A.2 Comments and Responses

Comments on Draft NUREG-1437 Supplement 23
Regarding the Point Beach Nuclear Plant License Renewal Application
(TAC Nos. MC2049 and MC2050)

**COMMENTS ON DRAFT NUREG-1437 SUPPLEMENT 23
REGARDING POINT BEACH NUCLEAR PLANT, UNITS 1 AND 2
LICENSE RENEWAL APPLICATION**

FIGURE 3-1
Facility Layout

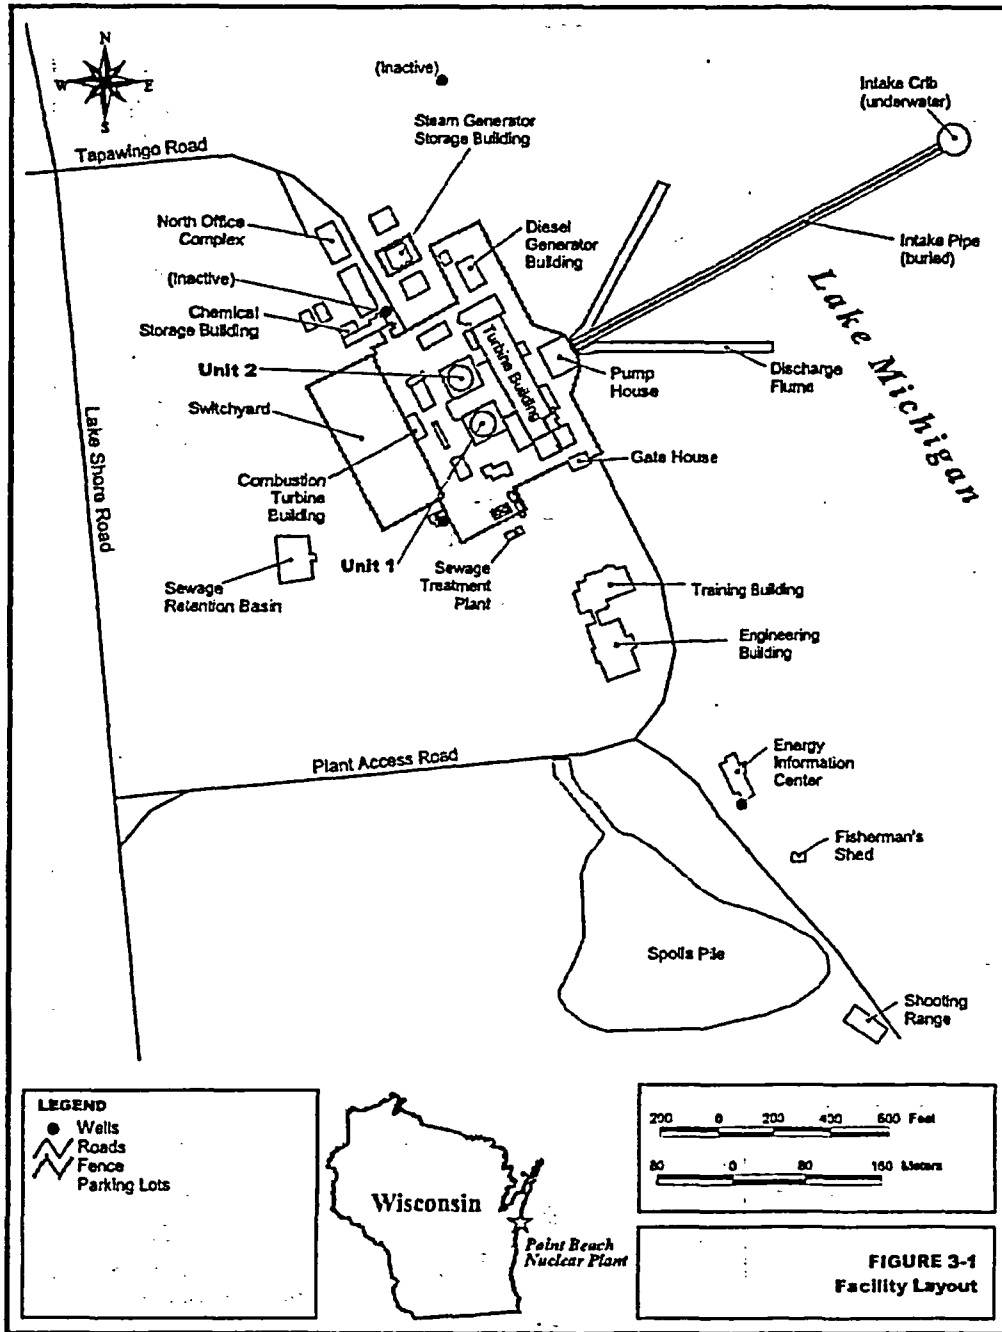
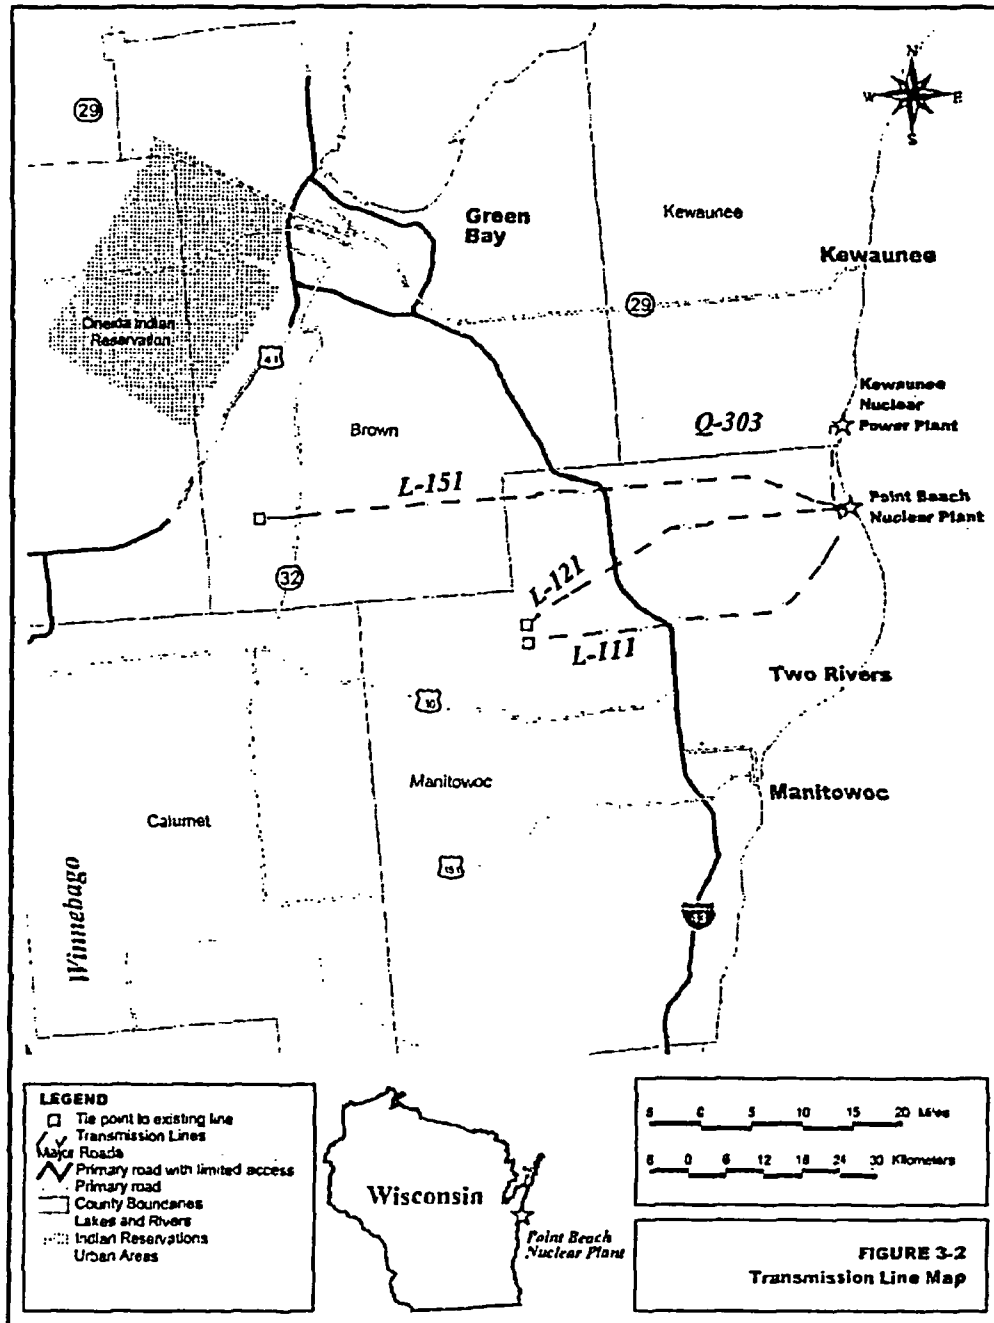
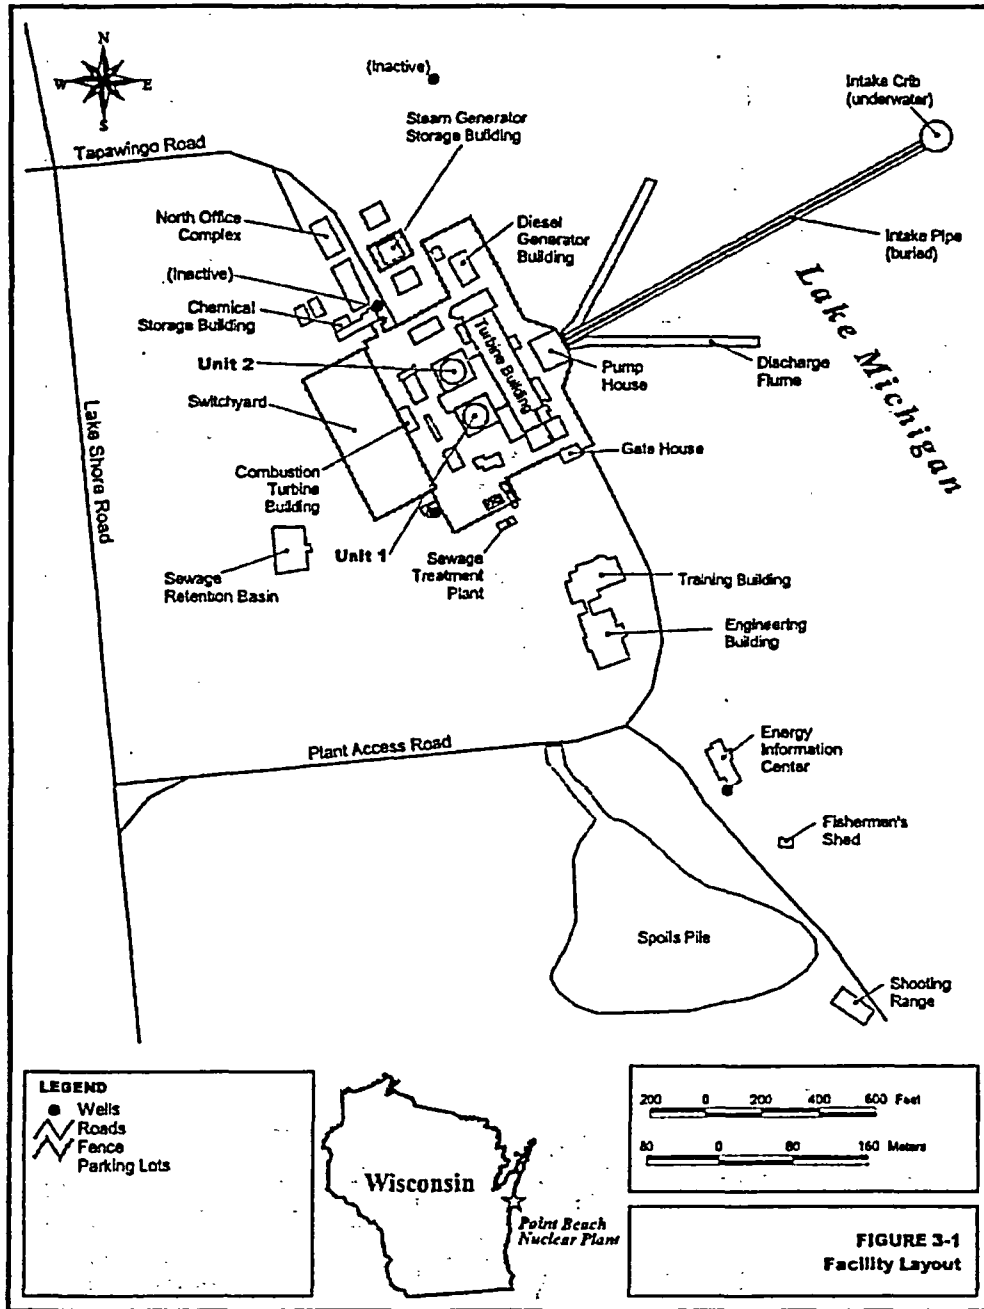
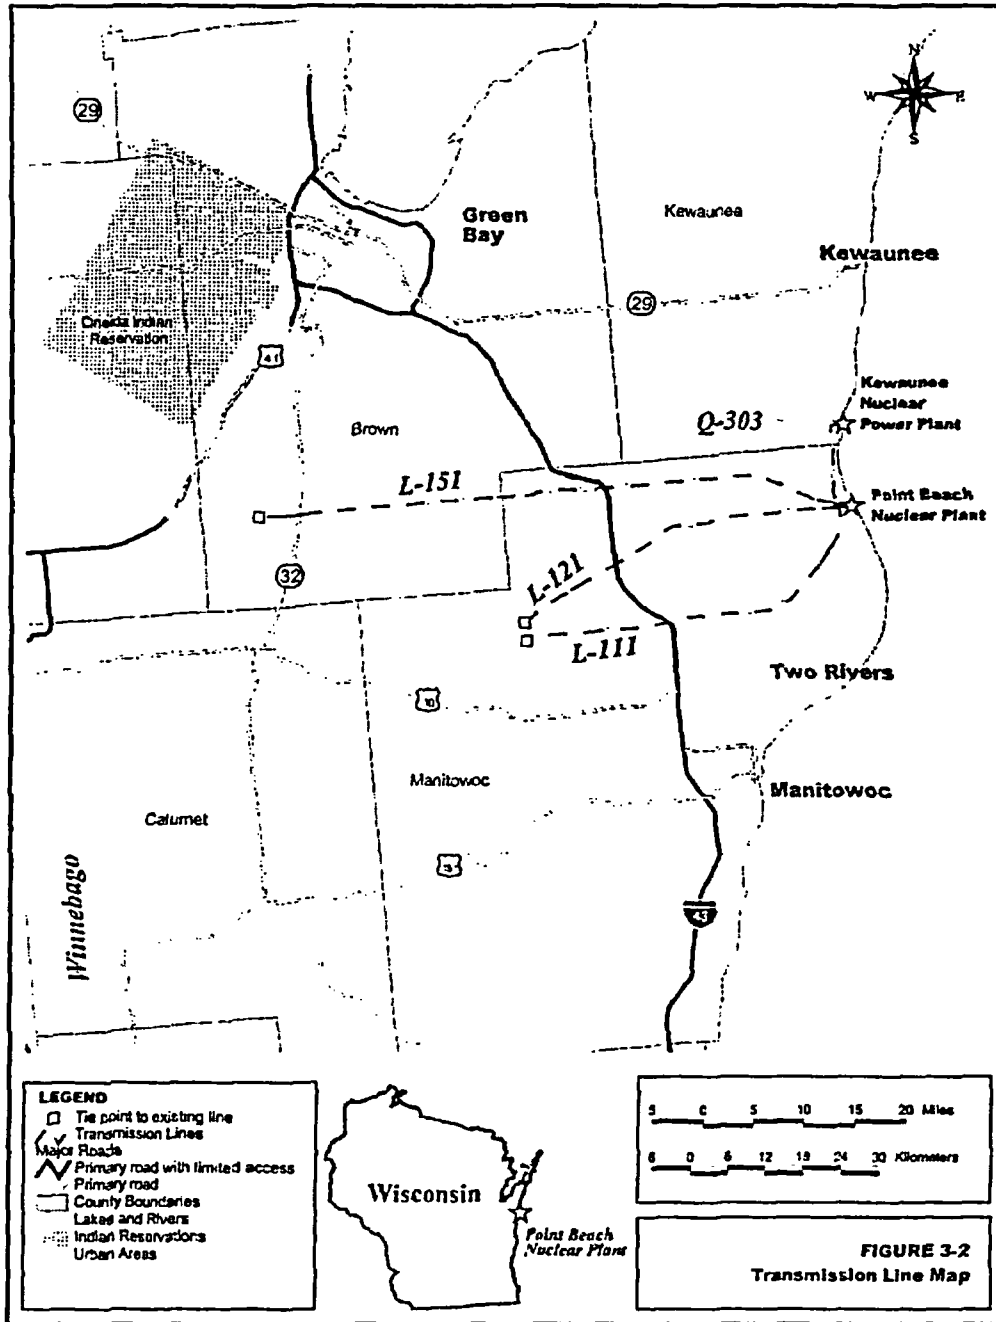
Comment: The drawing has holes in the fence perimeter at the northeast corner of the switchyard and the southeast corner of the switchyard. Consider revising the drawing to assure fence perimeter accurately reflects current design. (PB-CC-21)

Comment: The "Warehouse & Office" building (commonly referred to as the north gatehouse) has been demolished. Consider revising the drawing to depict that this building no longer exists. (PB-CC-22)

Response: *Figure 2-3 has been modified in response to the comment.*

Response: *Figure 2-3 has been modified in response to the comment.*
